STOCKTON UNIFIED SCHOOL DISTRICT

Expanded Learning Opportunities Program (ELOP) - Relocatable Classroom Buildings

The following additions, deletions and revisions to the plans, specifications and Addenda shall become a part of the plans and specifications. It is the responsibility of the General Contractor to submit the information contained in this addendum to all subcontractors and suppliers. The Bidder shall acknowledge receipt of the Addendum in the Bid Proposal. (Addendum number of pages: **32** pages + **77** attachments = **109** total pages).

JOB NUMBER:
23-12899
 DWG. DATE:
02/19/25
 AD1-PEY-
 A101

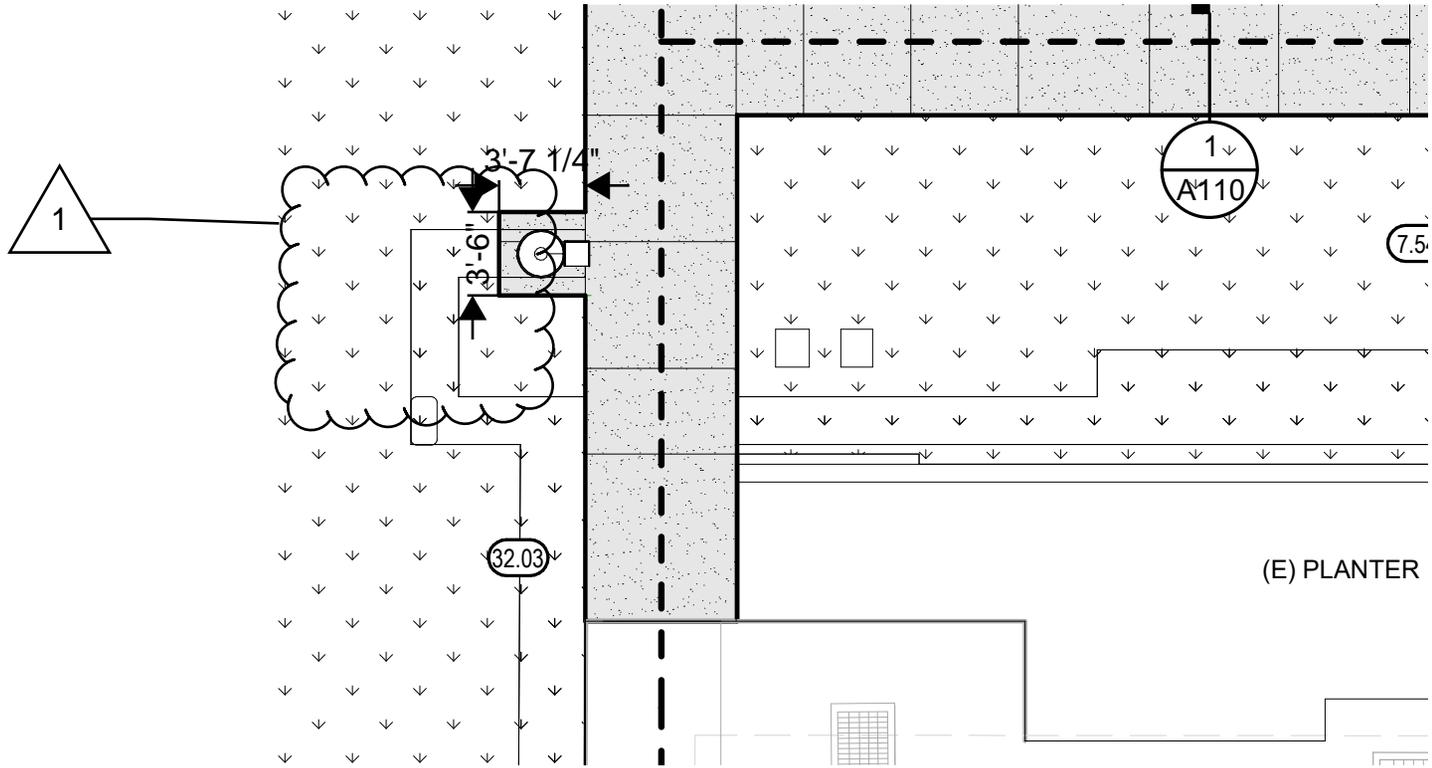
- 1 - 08: DRAWINGS, SHEET A101 – “DEMOLITION AND PROPOSED PARTIAL SITE PLAN”,** revise as follows:
- A. Per attached drawing **AD1-PEY-A101**.
 - 1. Concrete mow strip has been added around proposed light pole.

**AD1-PEY-
A102**

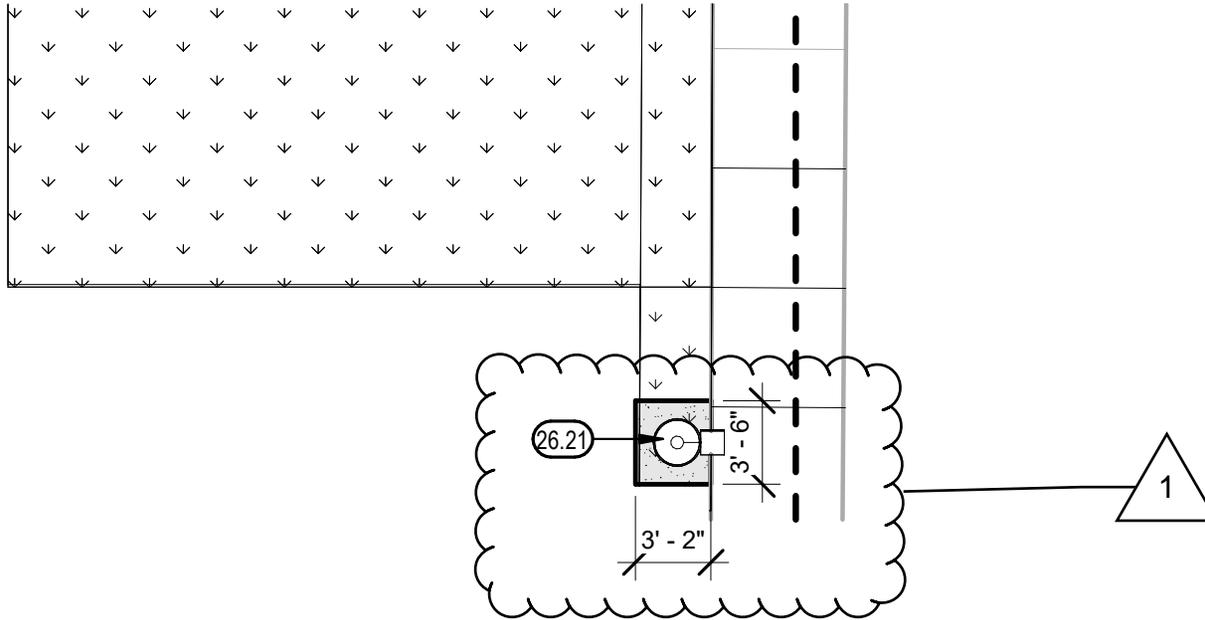
- 1 - 09: DRAWINGS, SHEET A102 – “DEMOLITION AND PROPOSED PARTIAL TRENCHING PLANS”,** revise as follows:
- A. Per attached drawing **AD1-PEY-A102**.
 - 1. Concrete mow strip has been added around proposed light pole.

FOUNDATION PLAN - VENTING

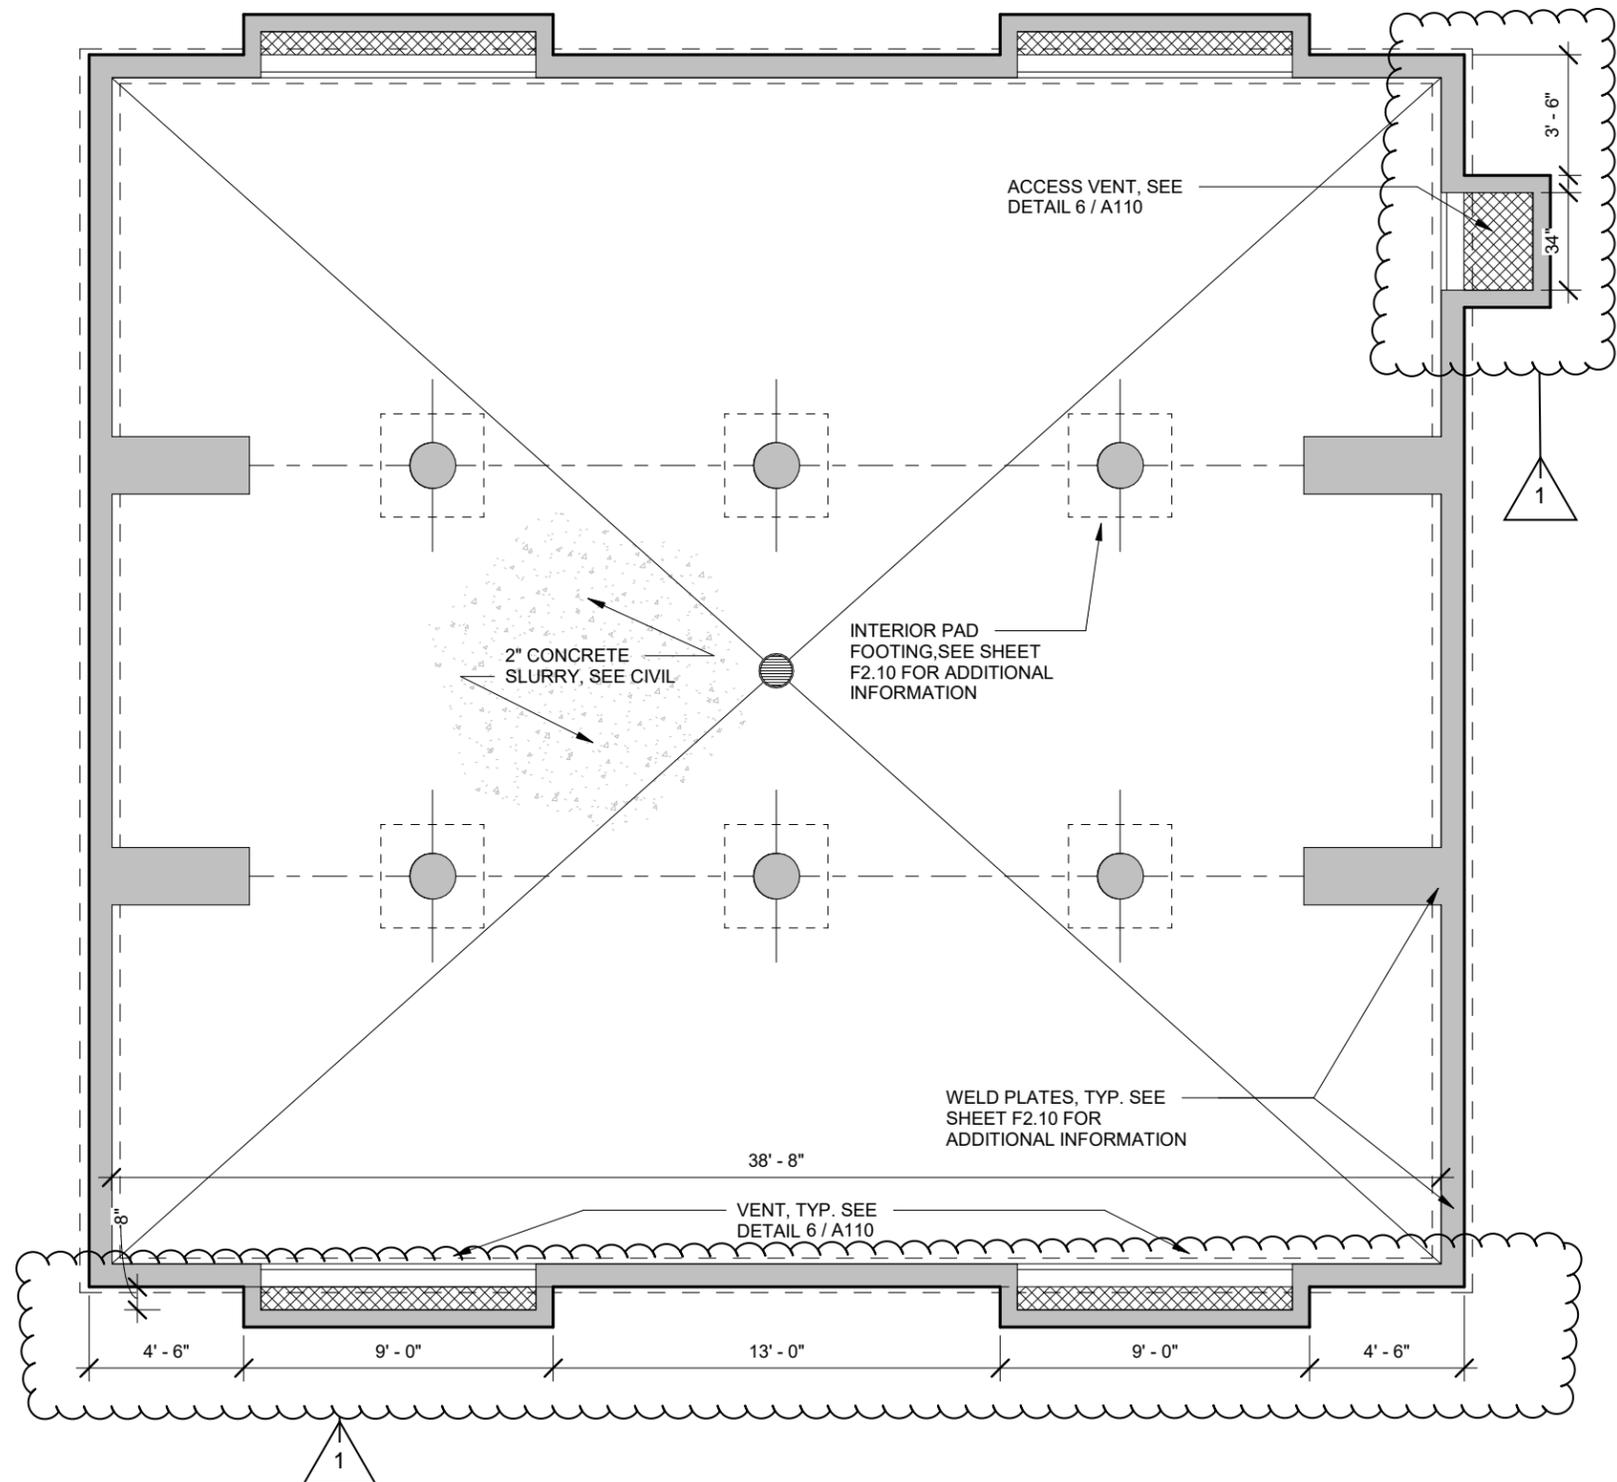
- 1 - 010: DRAWINGS SHEET A202 - “VENTING FLOOR PLANS”,** revise as follows:
- A. Per attached drawing **AD1-PEY-A202**.
 - 1. Foundation plan vent dimensions have been revised.

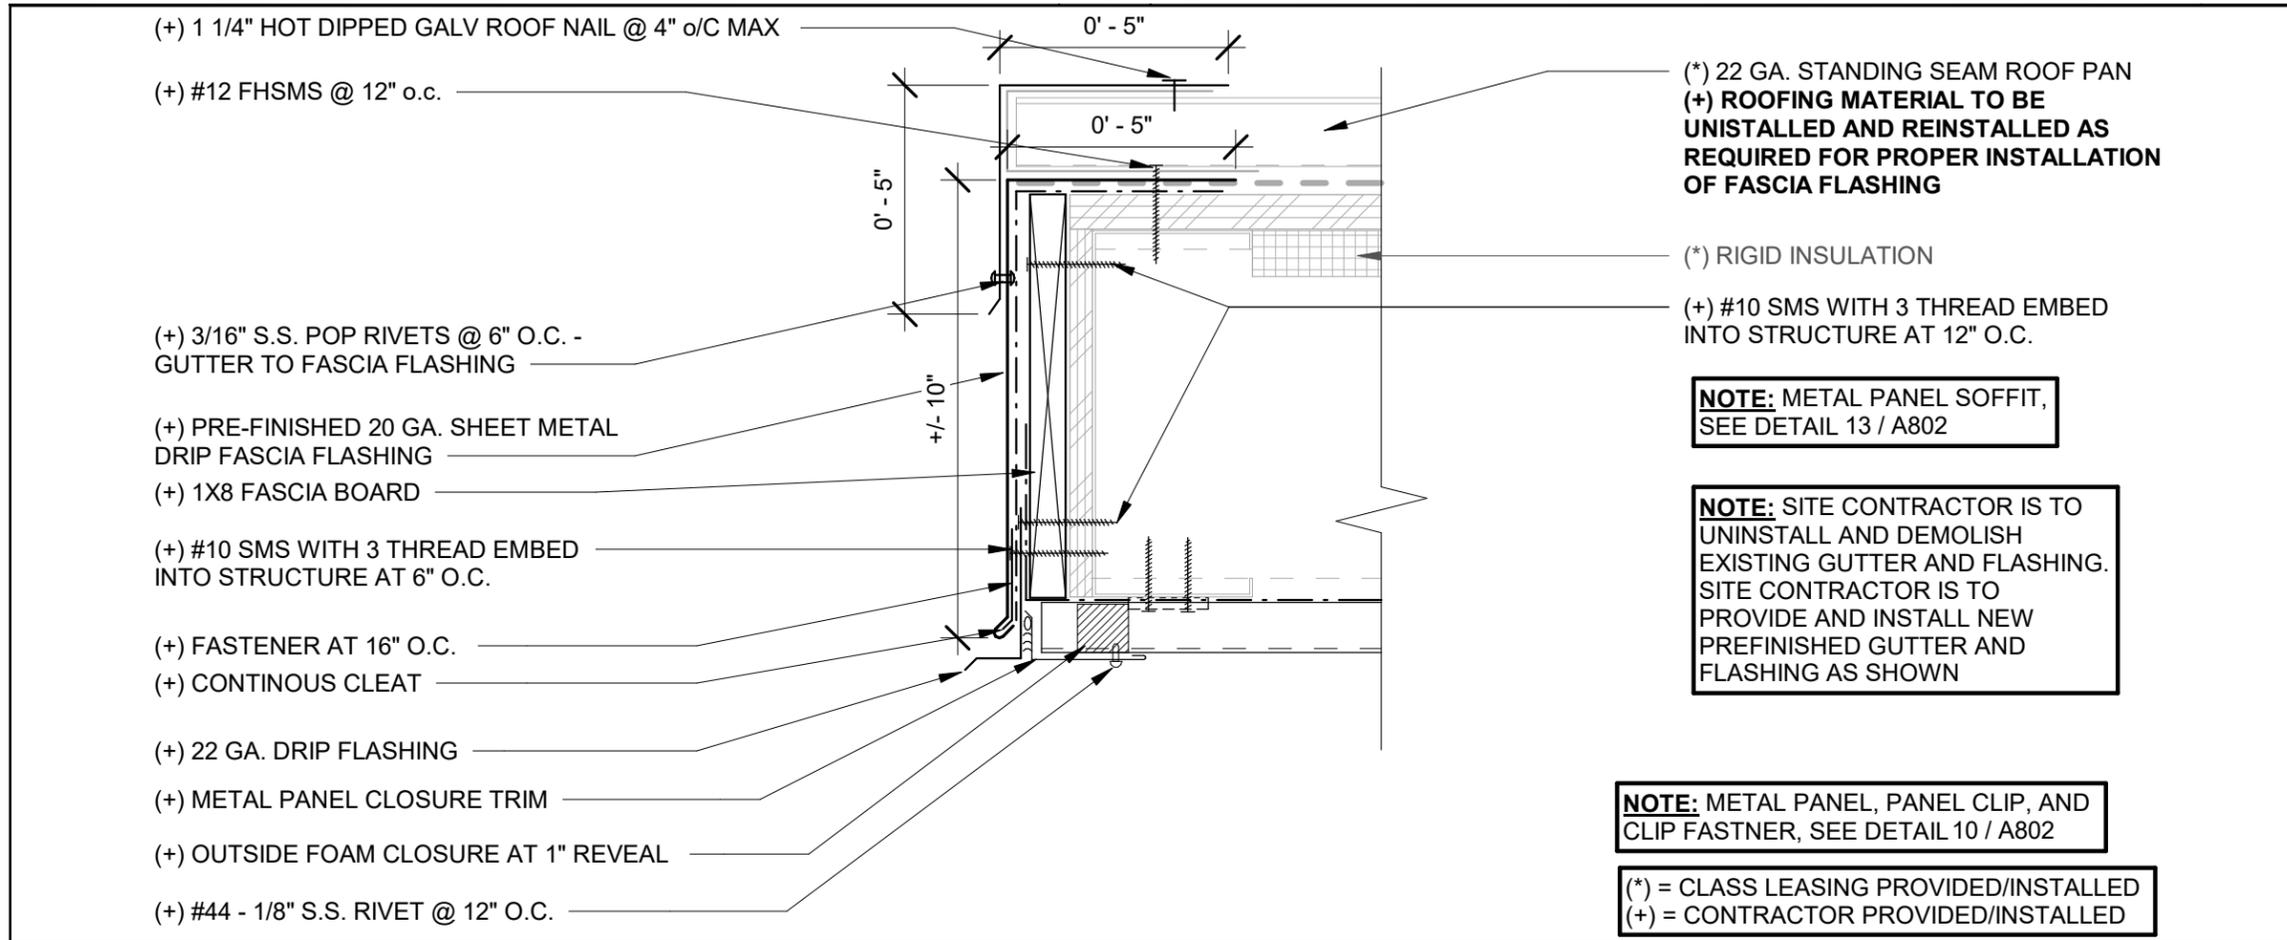
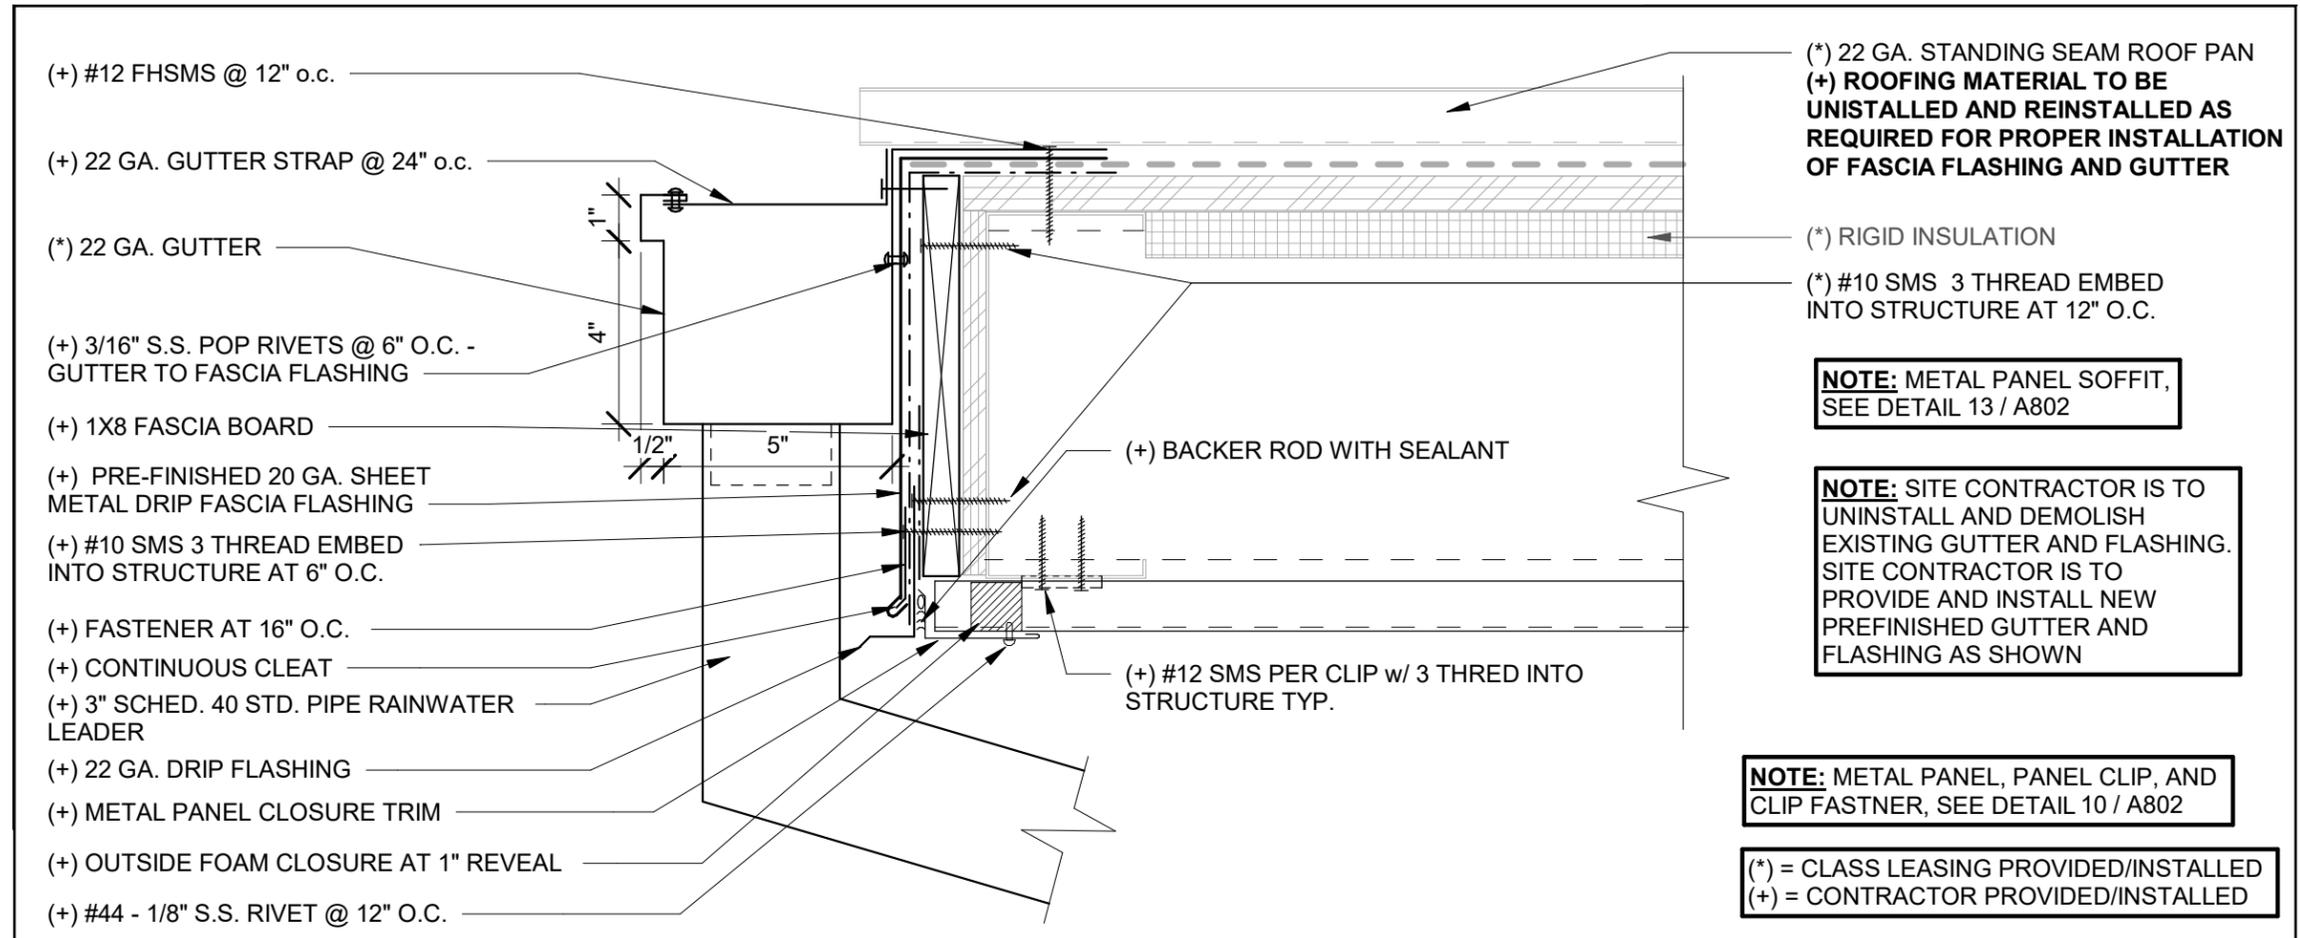
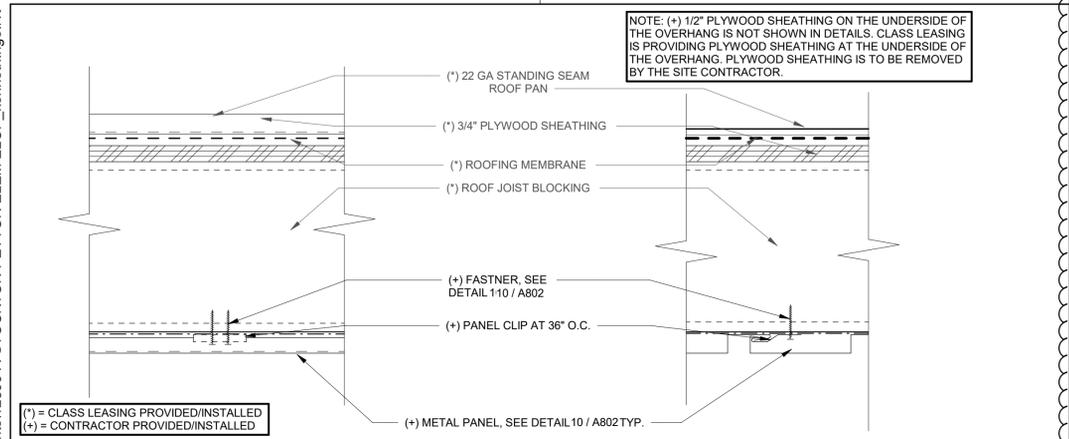
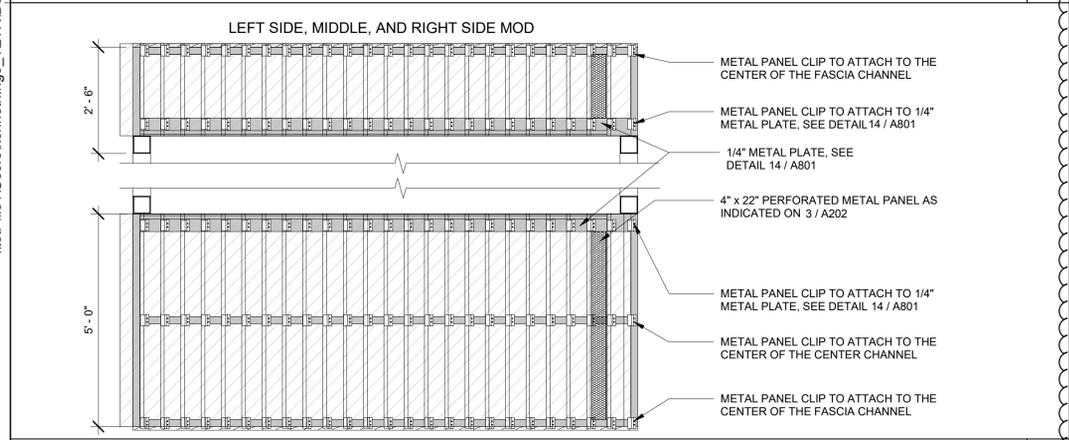
- 1 - 011: DRAWINGS, SHEET A801 - “EXTERIOR DETAILS (LAP SIDING)”,** revise as follows:
- A. Per attached drawing **AD1-PEY-A801**
 - 1. Details 12 and 13 - Additional fastener information has been provided.

PROJECT NO.
 23-12900.00
 DRAWING
 AD1-TAY-
 A112

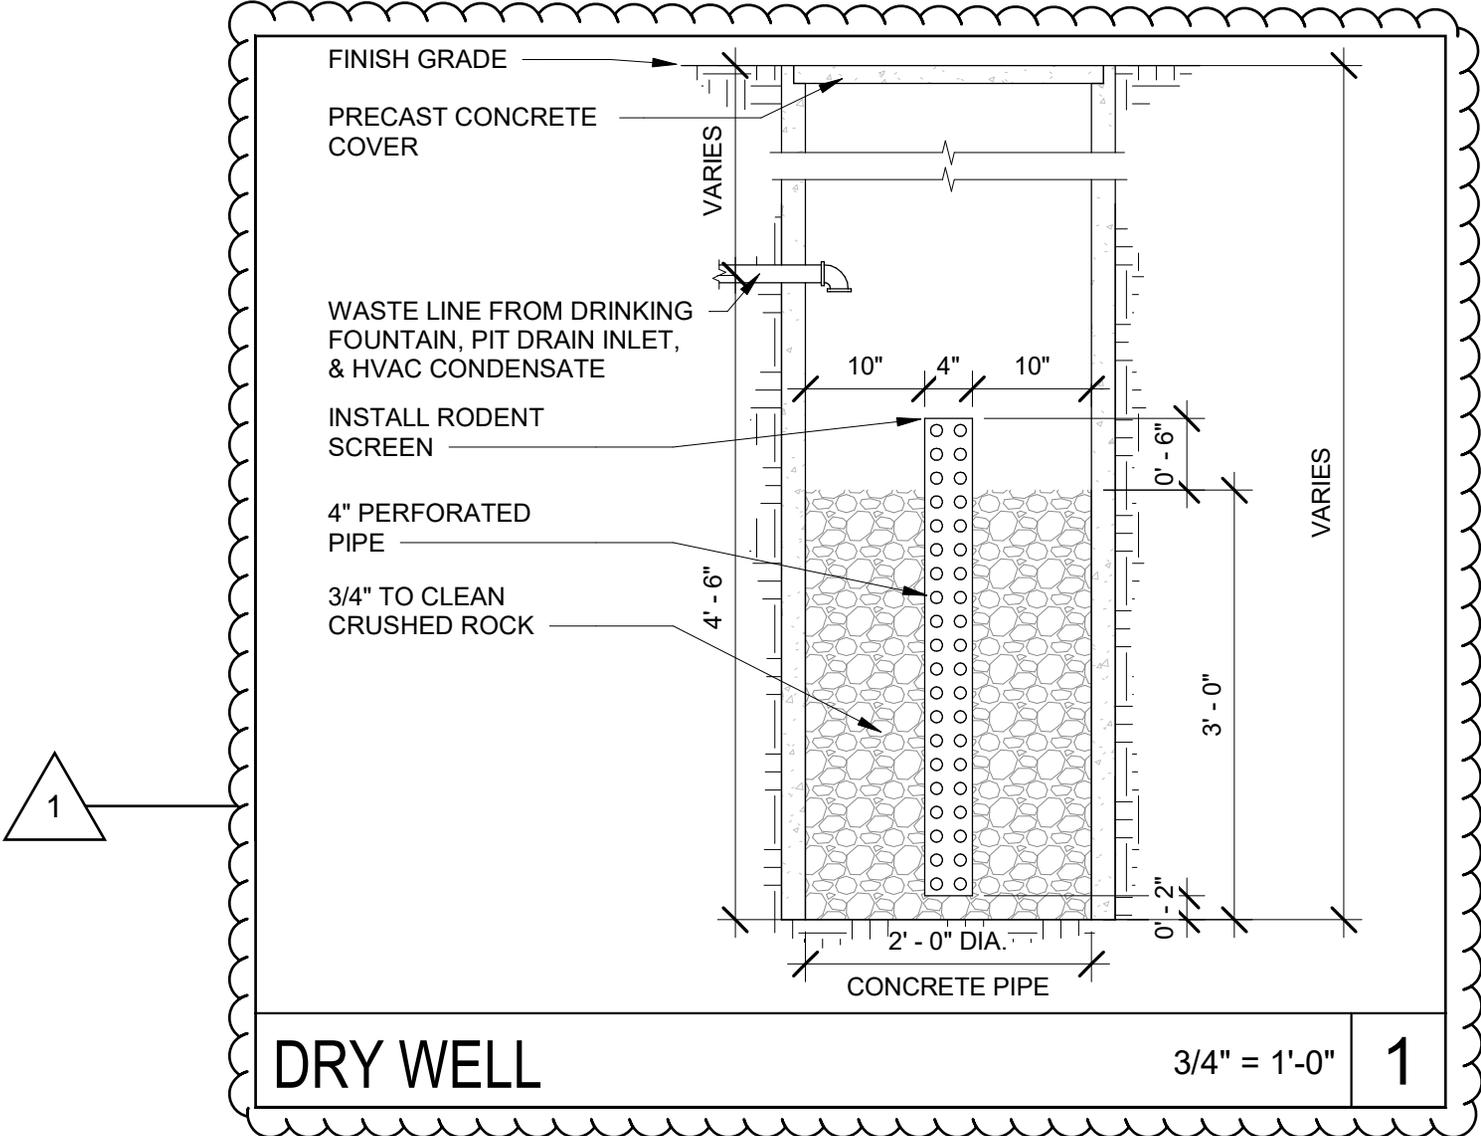
DRAWINGS:**1 - 021: DRAWINGS, SHEET A112 – “SITE DETAILS”,** revise as follows:A. Per attached drawing **AD1-TAY-A112.**

1. Details 10, 11, and 12 have been revised.
2. Detail 16 has been crossed out.
3. Detail 19 has been added.
